# AMENDMENT

**TBR 12**

**A1**

**Business TeleCommunications (BTC);  
Open Network Provision (ONP) technical requirements;  
2 048 kbit/s digital unstructured leased line (D2048U);  
Attachment requirements for terminal equipment interface**

Figure 1

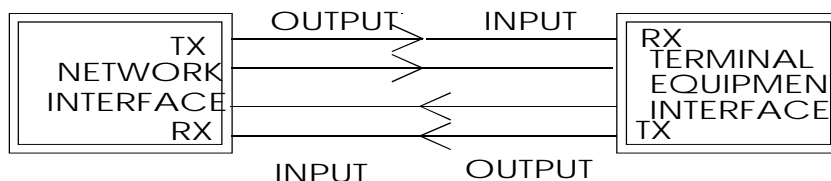
The transmit pair is the output from the terminal equipment interface. The receive pair is the input to the terminal equipment interface, as shown in figure 1. Where the terms "output" and "input" are used without qualification in this TBR, they refer to the terminal equipment interface.
